Interactive comment on “Sediment yield model implementation based on check dam infill stratigraphy in a semiarid Mediterranean catchment” by G. Bussi et al.

G. Bussi et al.

Received and published: 16 May 2013

Fig. 1. Sediment sub-model spatial validation.

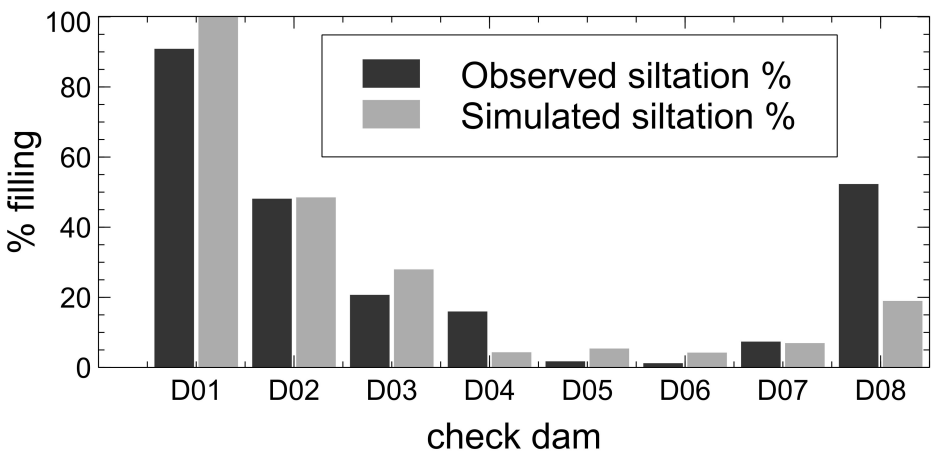
The reviewer states that “One of the main problems associated with more process-oriented models (compared to eg RUSLE approach) is that it requires a lot of field data and many parameters need to be (locally) calibrated. Here, the hydrological TETIS models requires 9 calibration parameters and the sediment sub-routine another 2. With 11 calibration parameters, it is not surprising to see that the model predictions are quite good: the more knobs you can turn, the better the result will be. But this doesn't mean that model really captures well what happens. In fact, the model is only calibrated at the outlet of the catchment so all internal processes are lumped: despite the fact that the model is said to be distributed, it is validated/calibrated in a lumped way and there is no guarantee that the various processes operating in the catchment are simulated well. This also means that extrapolation of the model to other catchments will be

very difficult lowering the potential of the model for predictions strongly. None of these deficiencies is really discussed.”

In order to clarify this point, we carried out a spatial validation of the sediment sub-model, by using seven check dams, similar to the one described in the paper, distributed all over the catchment headwater, although we only know the present sediment volume at each of them. We applied the TETIS model in order to reproduce the sedimentation final state of each one. This validation was mentioned in the response to Reviewer #1 and was also detailed in Bussi et al. [2012b], but was initially not included in this paper. Nevertheless, we think that, seen the question raised by reviewer #1 and #4, the spatial validation should be incorporated to the revised version of this paper.

The results are shown in Fig. 1. Check dam 2 represents the check dam described in the paper. The agreement is substantially good for check dam from 1 to 7. The only relevant error can be seen in check dam 8, probably due to a poor characterisation of the check dam deposits.

In other words, the model (hydrology and sediment sub-models) can be considered spatially validated.

Fig. 2. Temporal evolution of sediment yield and sediment trap efficiency.

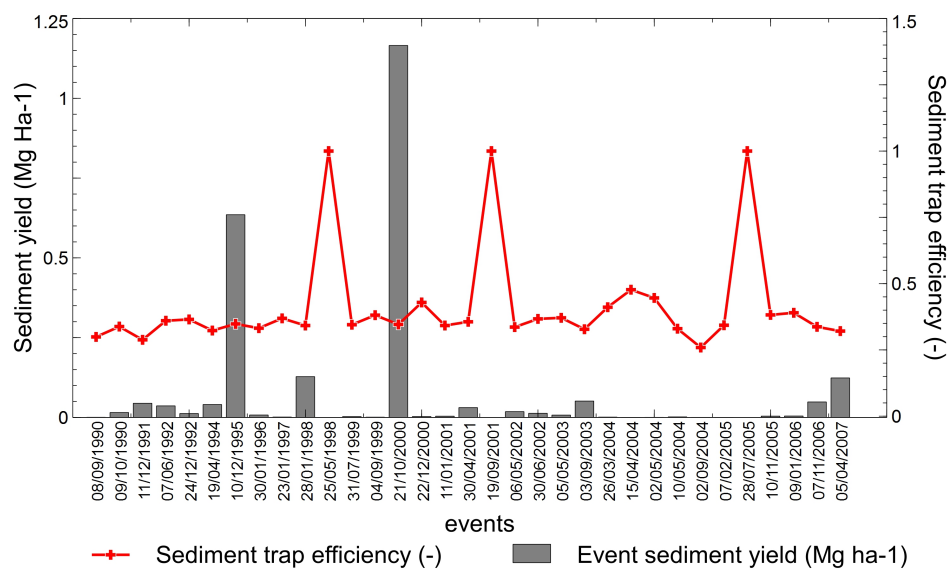
“It would be revealing to see a temporal graph with declining TE and varying SY”

We attach a graph (Fig. 2) in which the sediment yield and the trap efficiency are

shown for each event. A decreasing trend in trap efficiency cannot be seen because many other variables are involved into TE computing a part of the reservoir capacity (influent water and sediment discharge, sediment texture and settling velocity, etc.). Three events show a TE of 100%, due to their low magnitude. We think it will not be profitable to add this figure and the corresponding comments in the final paper.

Fig. 3. Comparison between the measured and simulated sand content of each sediment layer (the texture of the layer BG-4 could not be measured).

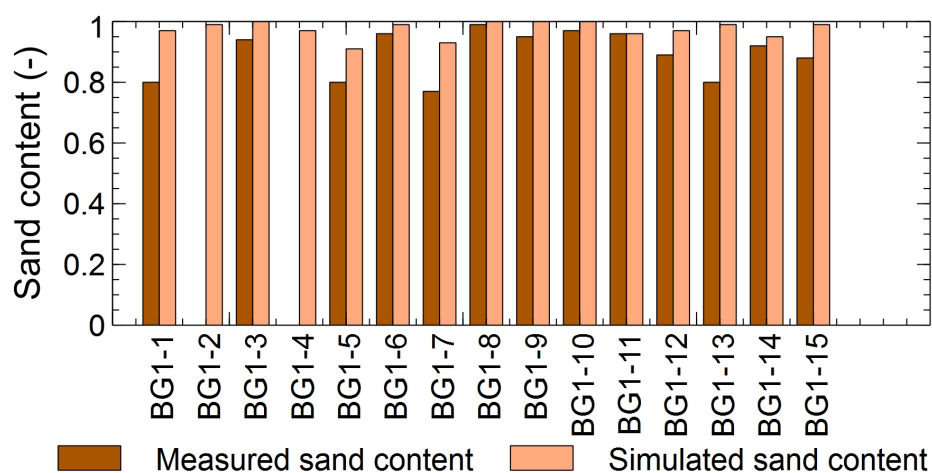
“The authors state the modelled texture of deposited sediment agrees with field measurement but nowhere data is shown to illustrate this and that could support this.”

As a confirmation of this statement we attach a graph (Fig. 3) in which the comparison between the measured and the simulated sand content of each layer can be seen. This figure confirms the substantially good performance of the STEP model in reproducing the texture of the deposited material. We will add this graph to the revised version of the paper.
